APPLICATION FOR APPROVAL OF AN INDIVIDUAL SEWAGE DISPOSAL SYSTEM

Additional info in the
case of the sewage
permit appl. 220-158
of: Mr. Anthony Santilli

SUBJECT: A. Santilli, Pole #2916 Conanicut Road, Narragansett, Rhode Island
#220-158

Application No. 220158 Dated 8 August 1972
for A. Santilli

CROSS OF SECTION
DISPOSAL BED

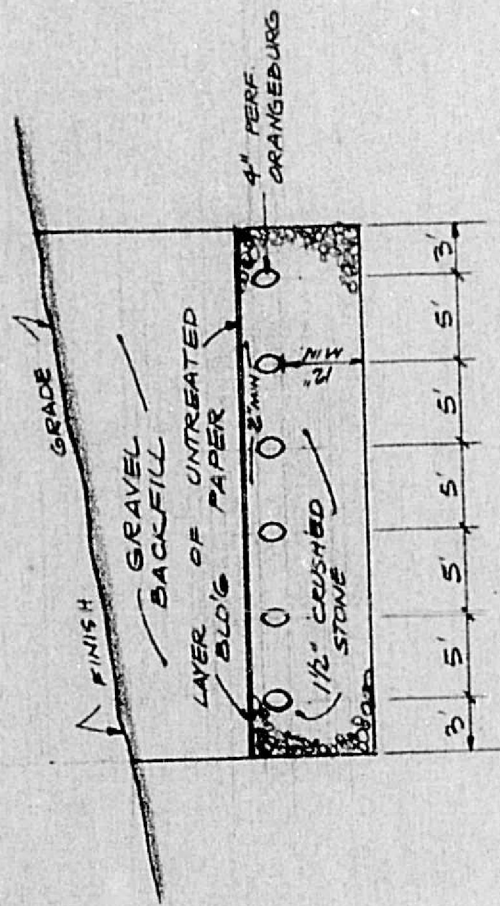
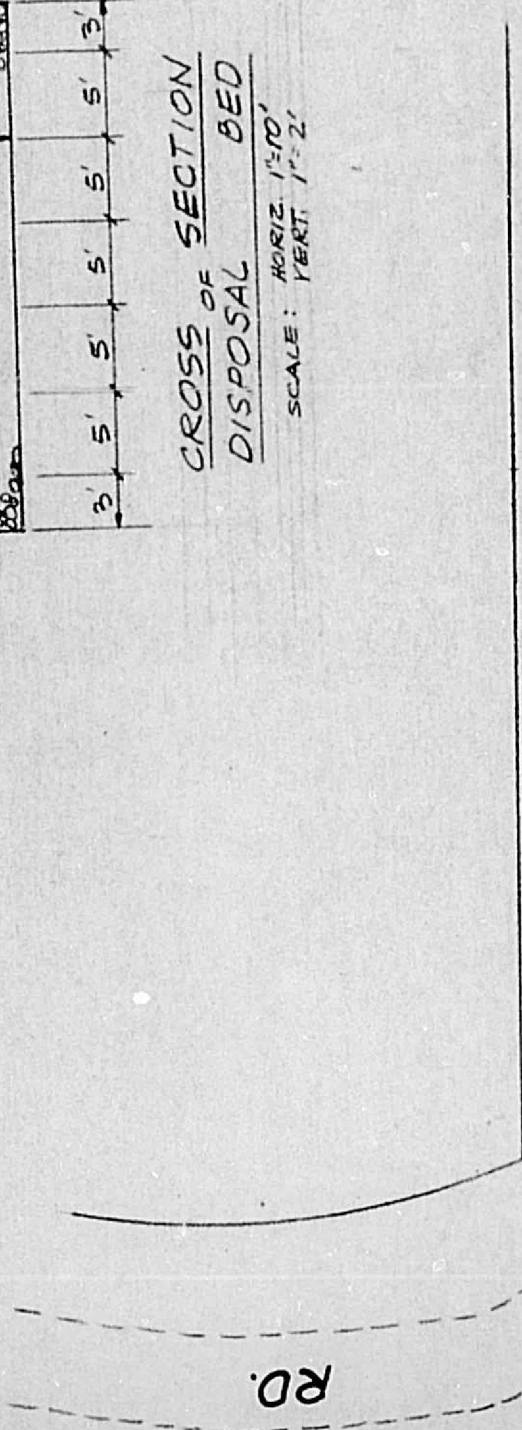
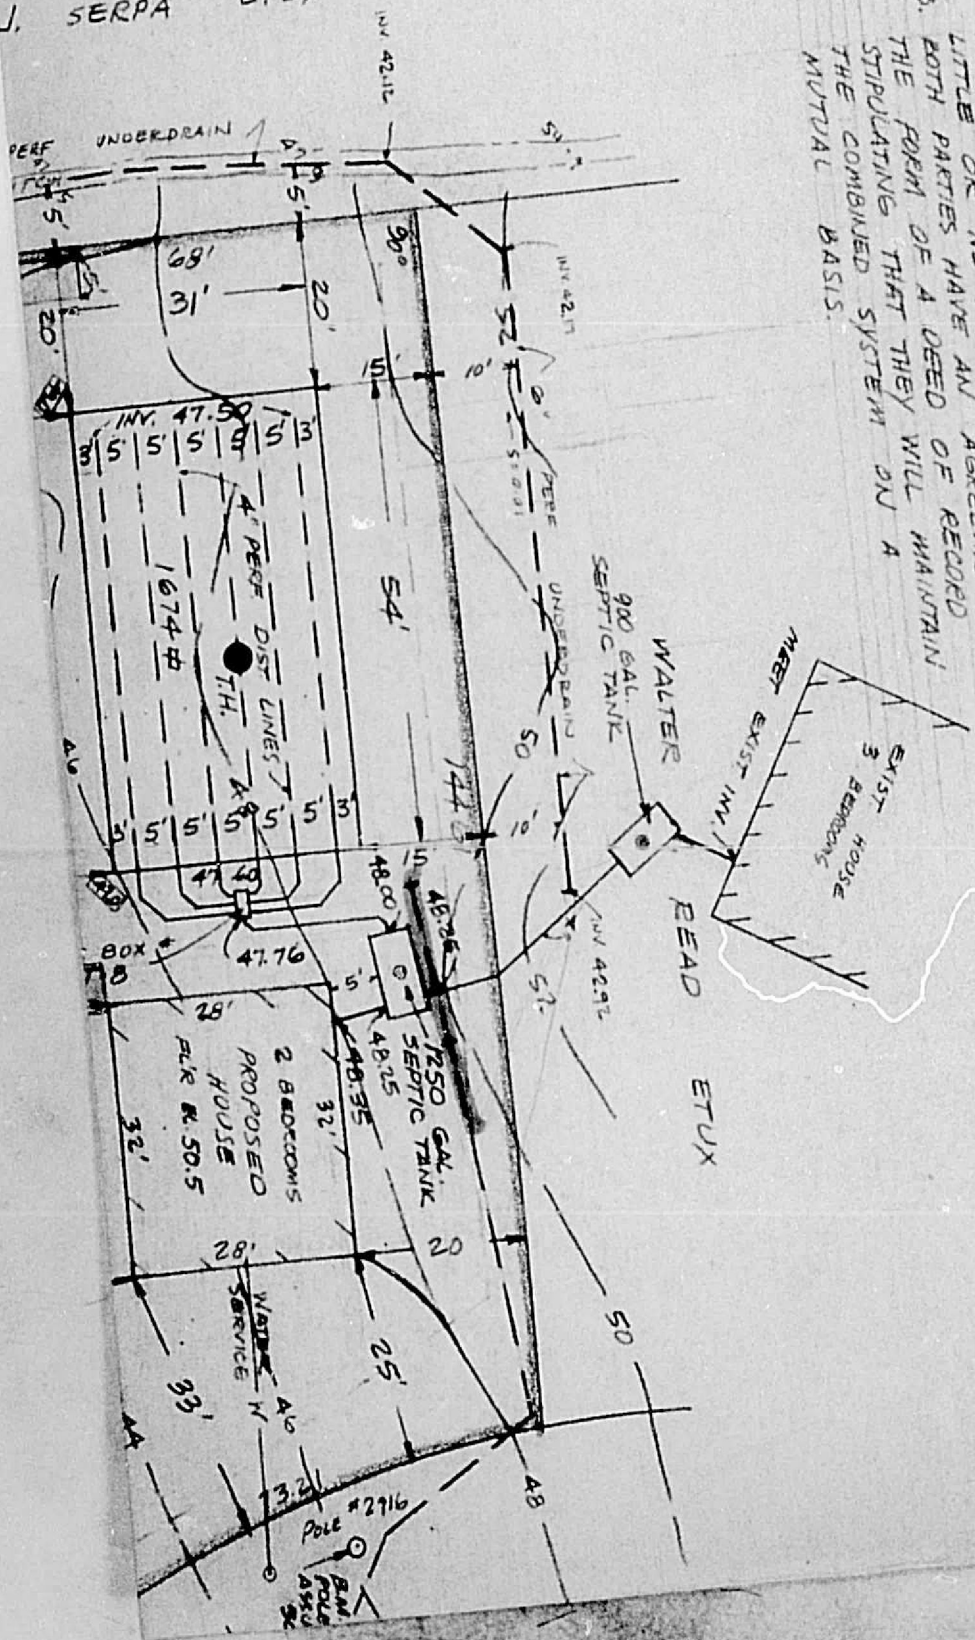
2. - THE OPEN TRENCH RUNNING EAST-WEST ON THE ABUTTING PROPERTY (LOT 261) PERHAPS CAN BE CLASSIFIED AS A SEASONAL BROOK, WHICH WOULD CHANGE THE MINIMUM DISTANCE REQUIREMENT TO 50 FEET RATHER THAN THE 25 FOOT MINIMUM DESIGNATED ON THE PLAN (FOR A SUBSURFACE DRAIN). INSPECTION OF THE SITE WOULD HAVE TO BE MADE BY MR. MURGO, PREFERABLY IN THE RAINY SEASON, BEFORE A DECISION CAN BE MADE ON THIS POINT.

2. - THE SPECIFIC DESIGN OF THE DISPOSAL BED PREPARED BY MR. BOYER IS CORRECT FOR THE CONDITIONS NOTED, PROVIDED THE INSTALLATION IS CARRIED OUT IN CONFORMANCE WITH ESTABLISHED REQUIREMENTS AND PROCEDURES FOR USING FILLED LAND. WE HAVE ASKED MR. MURGO TO REVIEW THIS ASPECT OF THE DESIGN AND SPECIFICATIONS.

- 1). SD13.6, 12.5. The percolation test in question was run for only 3 hours instead of the required 4 hours. As the description of tightly packed silt with some granular material is in conflict with a 16 minimum rate, I feel any further percolation tests should be witnessed by your office.
- 2). SD14.2. No judgement at this time can be made to the whereabouts of the maximum ground water table.
- 3). SD2.15. The distribution from any subsurface drain or edge of any bank sloping to a level lower than the system shall be 25 feet. The east property line shows violations of both parts of this regulation.
- 4). SD8.5. A sewage seepage system shall not be constructed in filled land if the subsoil is of poor permeability. A soil with a rate over 10 minutes per inch is assumed to be of poor permeability.

- 1) SD13.6, 12.5 The percolation test in question was run for only 3 hours instead of the required 4 hours. As the description of tightly packed silt with some granular material is in conflict with a 16 minimum rate, I feel any further percolation tests should be witnessed.
- 2) SD14.2 No judgement at this time can be made to the whereabouts of the maximum ground water table.
- 3) SD2.15 The distribution from any subsurface drain or edge of any bank sloping to a level lower than the system shall be 25 feet. The east property line shows violations of both parts of this regulation.

- (1) Since the Water Table fluctuated from elevation 43.2' to 45.0' & back to 43.4' during the Dry Season, it is evident that the Subsurface Drains cannot contain any strong rain or runoff. The Water Table will continually rise above elevation 43.2'. The easiest way out would be to assume the Water Table to be at the surface and design on elevation 48.0' bringing Minimum Finish Grade to 53.5' instead of Water @ 43.5' and Finish Grade @ 49'. In the best interest of the owner this area should be stripped of present Fill to the Water Table in the Dry Season, backfilled with Bank Run Gravel and Designed at the highest Water Table Elevation (48.0').

- (2) The entire system should be shifted 10' Westerly. This relieves any affect on a Drain lower than a system and places the system 15' away from a Drain that is higher and reduces the chance of Contamination.

- (3) The 1250 Gallon Septic Tank is $1\frac{1}{2}$ Feet \pm from a drain-this Tank should have a Concrete Footing to prevent any movement.

(3) The design sub-surface leaching system must be shifted 10 feet to the west. This is a variance granted to provide additional protection to the property east of the Santilli lot. This variance is further granted because the general ground water flow is to the east which will give added protection against sewage seepage from the system to the drain.

(4) The first 25 feet of the drain located on the Santilli property on the westerly side flowing north must be cut off and removed to satisfy the requirements for distances from the sub-surface leaching system. This must be witnessed.

(a) The open ditch to the south of the Santilli property is in the opinion of those who reviewed the plans not a brook within the meaning of the regulations since it was established to provide for controlled flow of the installed ditches and surface drainage. Therefore, the 50-foot distance does not apply.

However, since the water table conditions observed indicate that the water table may rise to elevation 48 during a heavy rainfall, the point of reference for the location of the leach area is established at that point. The bottom of the leach system should be at elevation 51. The conditions of design as applying to filled land in the memorandum establishing the policy decision dated 14 September 1972 shall be adhered to.
